CITY OF WEST DES MOINES
CITY COUNCIL MEETING COMMUNICATION

ITEM: Courtyards at King's Landing (f/k/a Courtyards at Sugar Creek), Northeast corner of S. 100th Street and Stagecoach Drive– Subdivide property into 79 footprint lots, 1 street lot and 2 outlots – Caliber Iowa LLC. – PP-004322-2019

RESOLUTION: Approval of Preliminary Plat

Item: Courtyards at King's Landing, Northeast corner of S. 100th Street and Stagecoach Drive – Subdivide property into 79 footprint lots, 1 street lot and 2 outlots – Caliber Iowa LLC – PP-004322-2019

OVERALL SITE LAYOUT

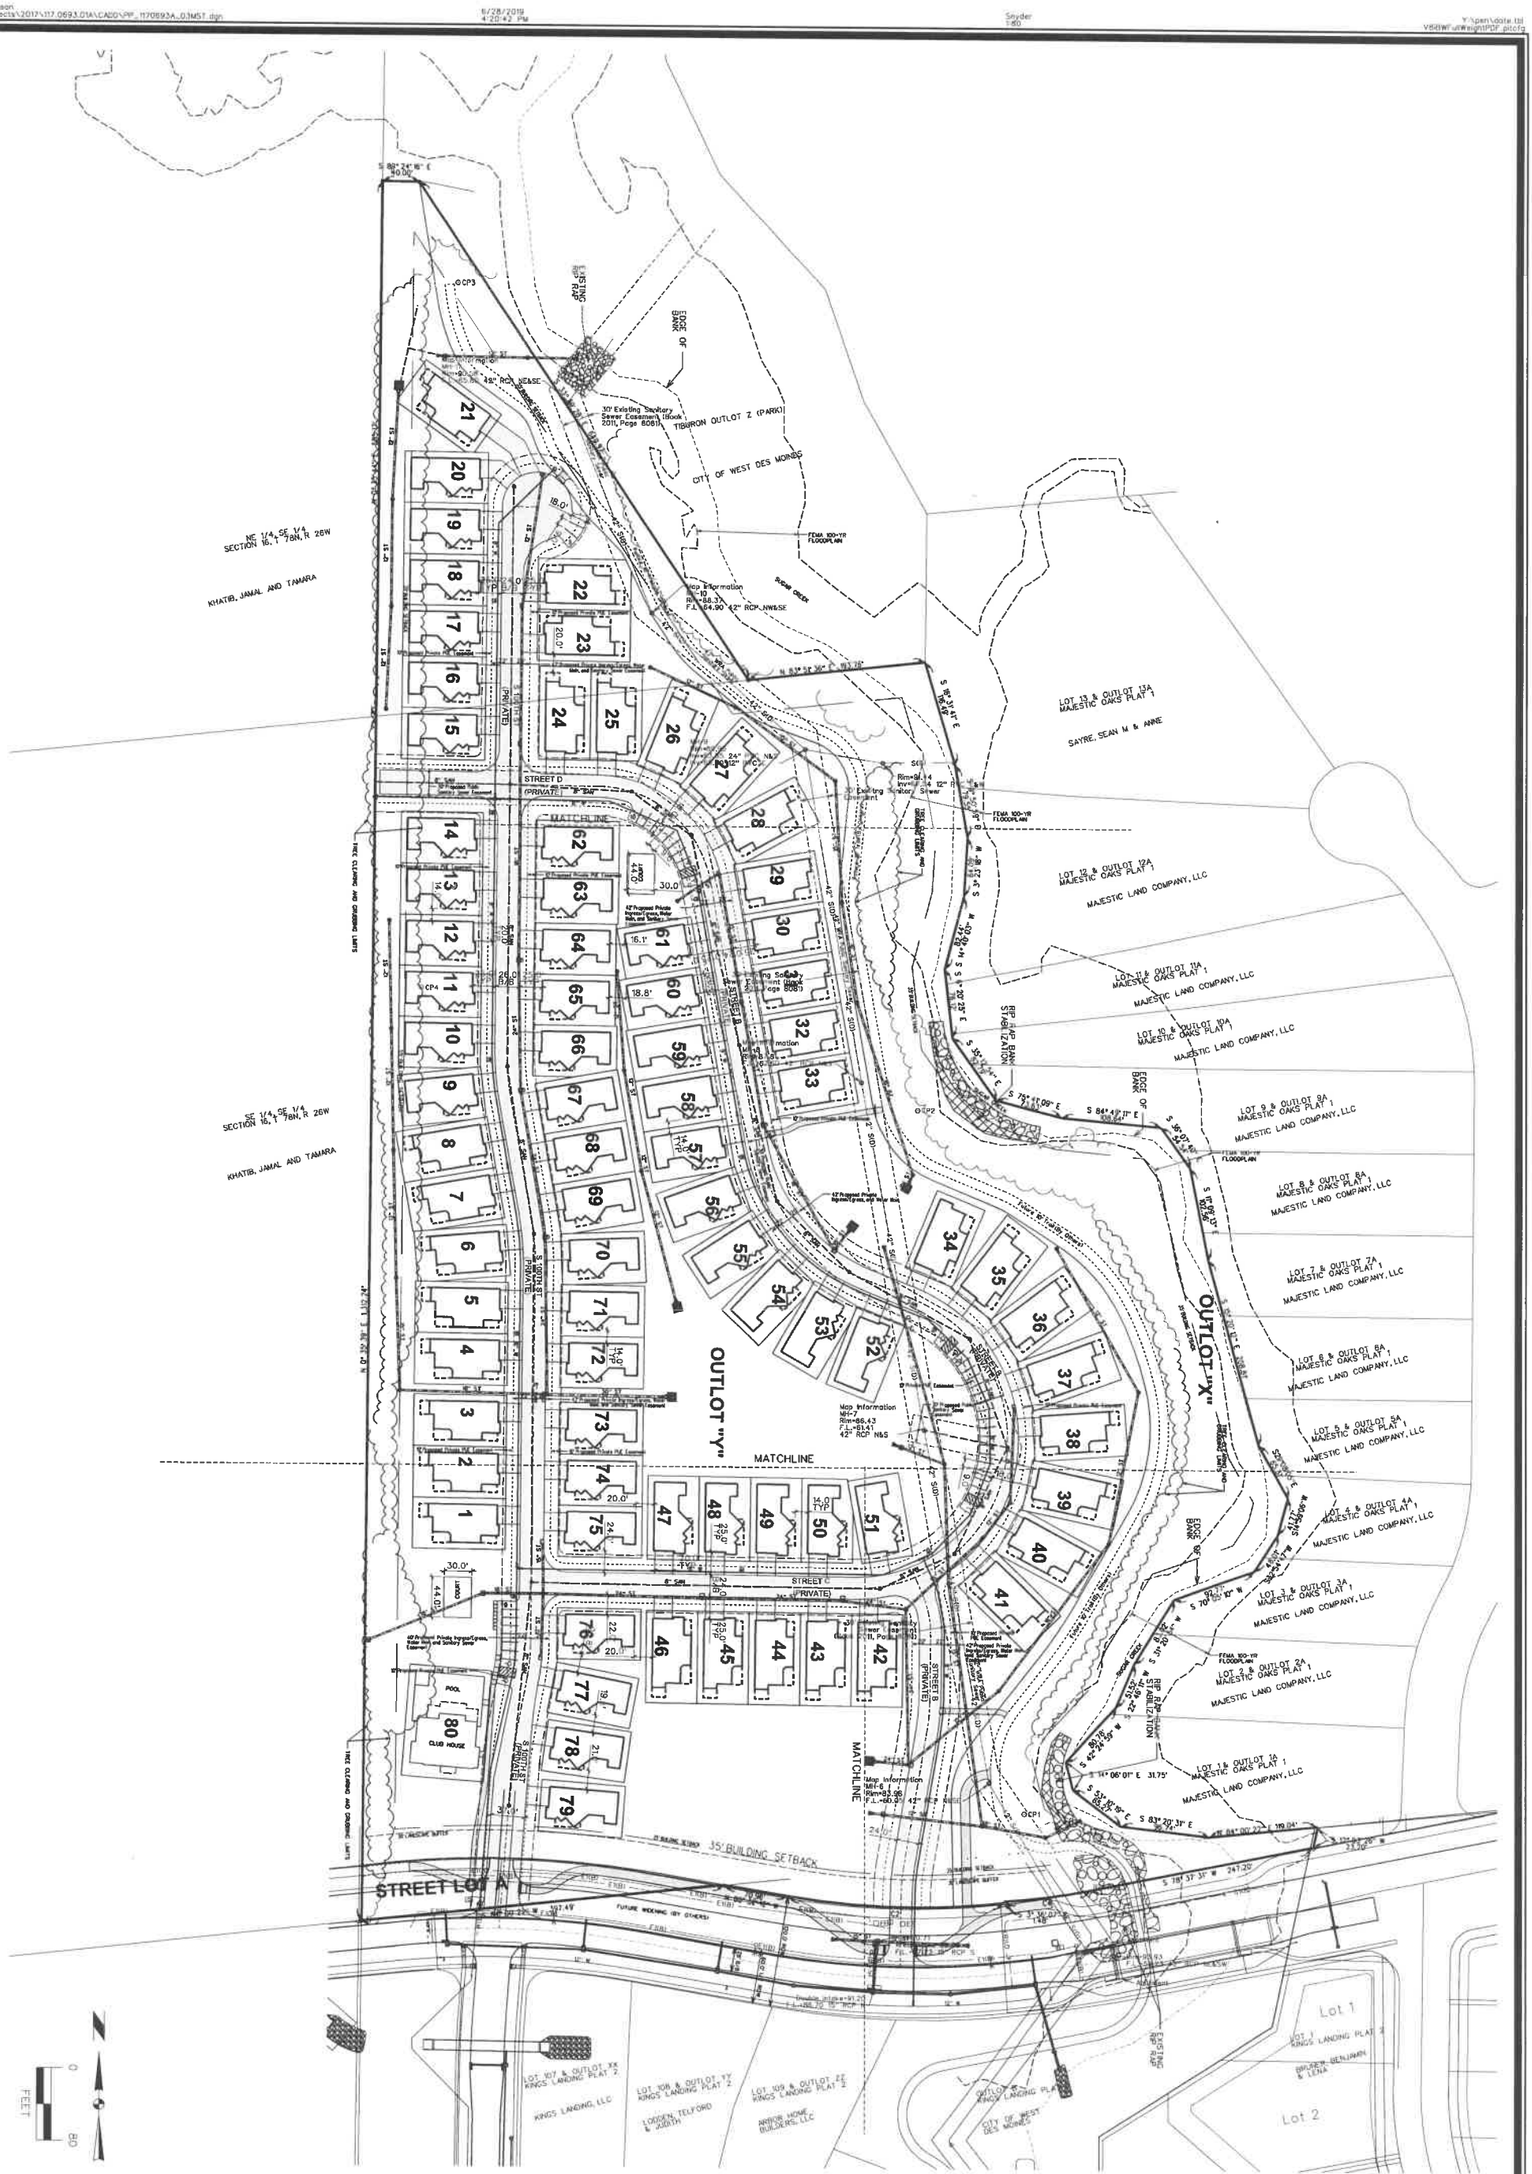
- *Easternmost Access from Stagecoach Drive:* The narrow triangular shape of this property along with topography and existing infrastructure has made providing two points of access to the development challenging. When driving west on Stagecoach Drive, you encounter a hill that slopes down towards Sugar Creek and the recently built bridge that crosses the creek. The 800 feet on the north side of Stagecoach beginning at the west end of the bridge is the entire frontage of the applicant's property. Within these 800 feet, the site needs to provide 2 points of access that comply with the Fire Code, meet the separation distance and expected turn lane storage requirements between the two drives and provide safe sight distance for drivers accessing Stagecoach Drive from the easternmost drive within the development. The topography and proximity of the drive to the bridge make it difficult to strictly comply with code and the desired sight distance. To address this issue and eliminate the need to sprinkler more than half of the dwellings until an alternate secondary access can be provided for the development, the applicant is proposing that the easternmost access into the site be a one-way in only drive. The one-way in only drive will eliminate outbound traffic turning onto Stagecoach Drive from the intersection reducing the possibility of vehicle crashes due to limited sight distance because of the bridge. While eastbound traffic has more visibility of west-bound traffic, staff still has concerns with the accident potential, especially when Stagecoach Drive is widened in the future. Staff is comfortable with using the one-way in only drive in the interim, but recommends a condition of approval that address the maximum width of the drive and the addition of traffic control signage and road markings, as well as a condition that requires the developer execute an agreement in

- *Sugar Creek Buffer and Measuring of Setback*: Some of the bends in Sugar Creek are known to experience bank erosion issues due to water volumes and velocity during heavy rains. Rather than have these areas be part of private homeowner's properties requiring individuals to figure out how to address the erosion, the City prefers these areas be located outside of the boundaries of their lots. While the ground could be retained in an outlot and maintained by a homeowner's association, ideally the City will obtain ownership thus allowing for stream bank maintenance as necessary. As outlined in a previous bullet, in conjunction with the provision of parkland dedication, the developer will be dedicating the ground immediately adjacent to the west side of the creek which will allow the City to maintain Sugar Creek banks as needed and appropriate. Since this area is located within the current plat boundaries and the development is utilizing footprint lots which does not give individual residents any rights to install amenities outside of the defined building footprint, unlike traditional single-family detached lots which have 'rear yards' for personal amenities, the applicant may use the area within outlot 'X' to fulfill the 35' rear yard setback required along the east.

1. The applicant acknowledging and agreeing that the easternmost access to Stagecoach Drive is temporary and will be disconnected from Stagecoach Drive when the planned connection to the west is completed. The applicant will need to execute a formal agreement acknowledging and agreeing to such for recordation with the Final Plat.

1. The applicant acknowledging and agreeing that the easternmost access to Stagecoach Drive is temporary and will be disconnected from Stagecoach Drive when the planned connection to S. Grand Prairie Parkway is completed to the west. The applicant will need to execute a formal agreement acknowledging and agreeing to such for recordation with the Final Plat.
